Safia Apparels Ltd

Plot-b-46/47 & 64/65, BSCIC Industrial Estate, Panchobati, Fatullah, Narayanganj
(23.62576, 90.47897)

12th April 2014

Observations

**Heavy floor loading: Toilet areas of both buildings
(slab build-up) and cantilever slab to Building 1
(high storage)**

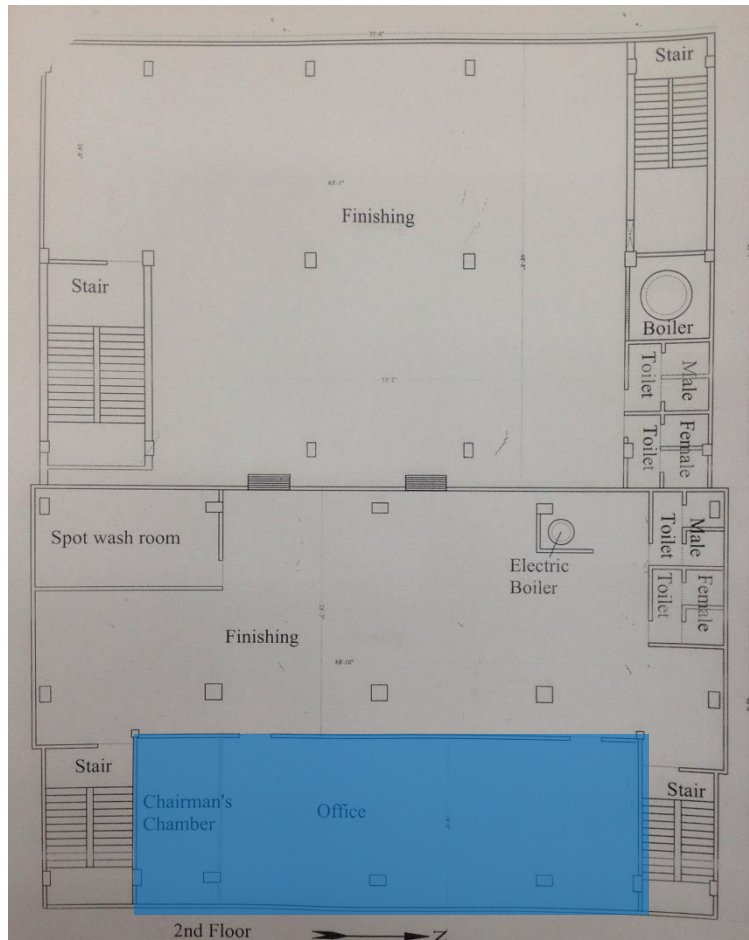
Heavy loading was noted in the toilets along the North elevation of Buildings 1 & 2, in the form of plinths and walls. Building Engineer to check that the slabs and beams have been adequately designed to accommodate this loading.

Heavy loading, in the form of temporary storage of fabric, was noted along the North elevation of Buildings 1, particularly to 4th and 5th Floor levels. Building Engineer to check that the slabs and beams have been adequately designed to accommodate these loadings, particularly at the cantilever location where there are no downstand beams.

Lack of any guarding / edge protection at Roof Level

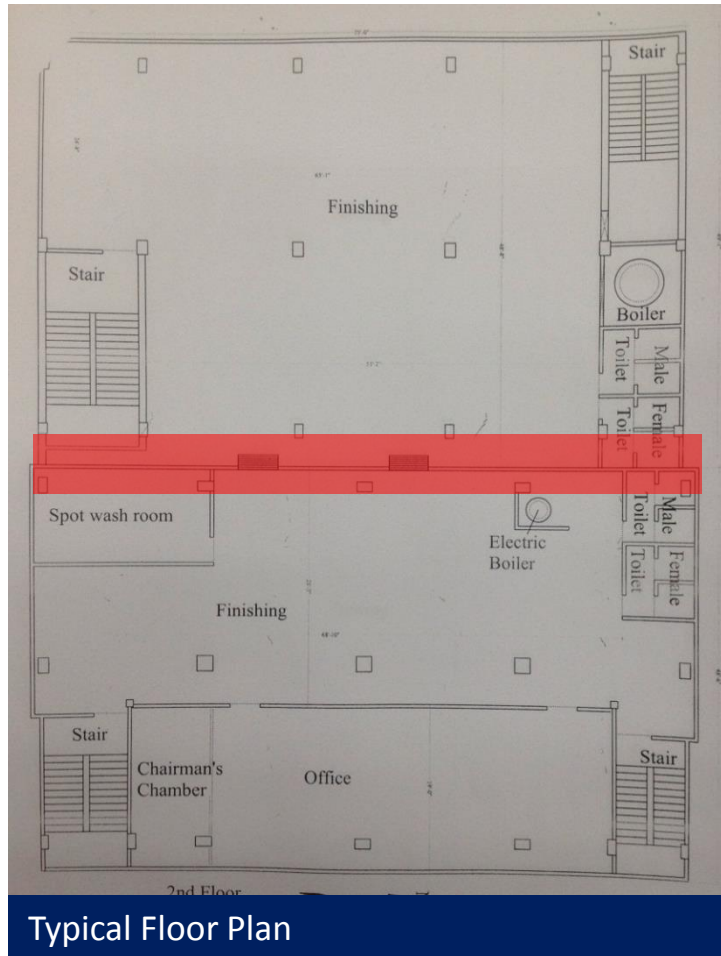
There is no edge protection to either building Roof, where construction works are ongoing. Building Engineer to install adequate fall barrier with immediate effect.

Bridging Detail at Building Interface

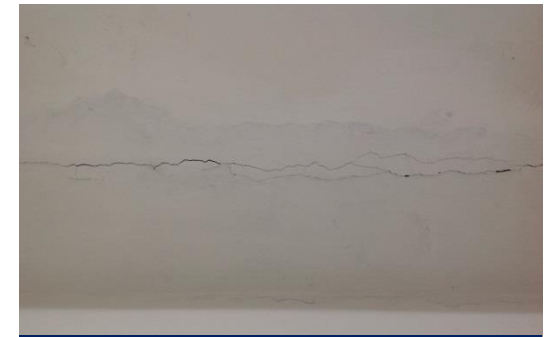
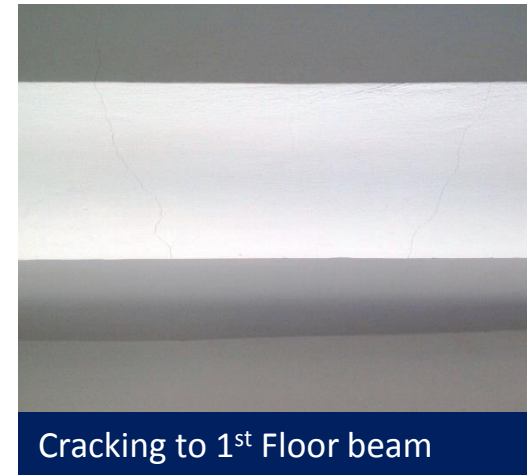
The connection detail between Buildings 1 & 2 bridging the expansion joint does not appear to be robust. The detail appears to consist simply of a slab that spans onto each building, but is not connected to either. Cracking was observed at the interface of both buildings. Building Engineer to clarify design and robustness of connection detail between Buildings 1 and 2, and to carryout any remedial works as required.

Apparently non engineered roof structure to stair enclosures above main roofs

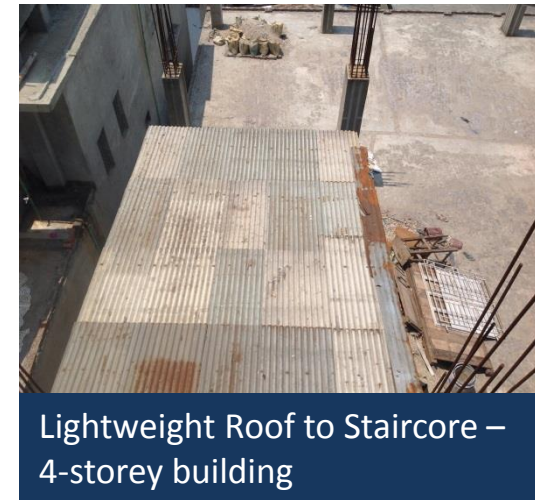
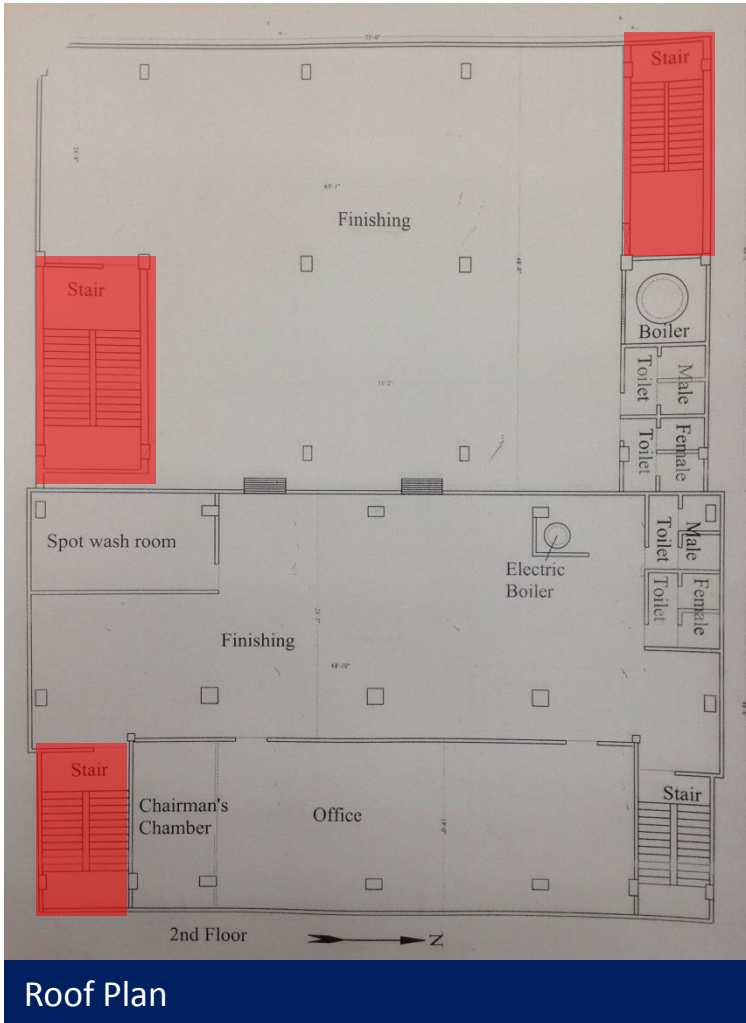
Building Engineer to review the design of the lightweight roof structures the staircores to both buildings, which do not appear to be engineered. Building Engineer to implement any upgrade works, including removing / securing loose metal sheeting, as required.

Building 2 – Typical Floor Plan

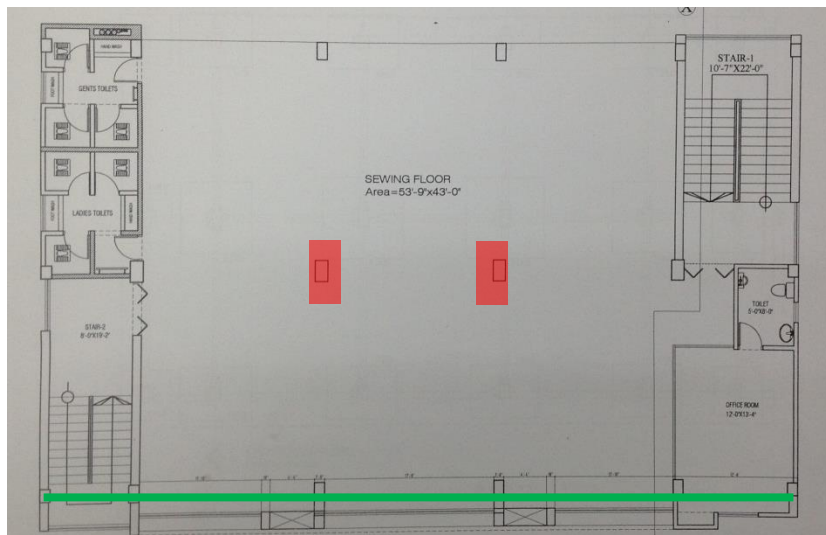
For Building 2, currently under construction, a set of As-built Structural Drawings (dated 2013), by ADEPT Consultants Ltd, was made available for review on the day of the survey. There are a number of inconsistencies between these drawings and the constructed building. A non-exhaustive list of issues include:

- Incorrect column sizes, particularly at Ground Floor level where the uniformity in internal column size indicated in the drawings is not apparent;
- Incorrect column reinforcement – the number of bars observed at Ground Floor level using the Ferroscanner was not in accordance with the drawings;
- The building line to the North elevation, adjacent to the South Elevation of Building 1, does not appear to be correct.

Building Engineer to review and provide clarification.
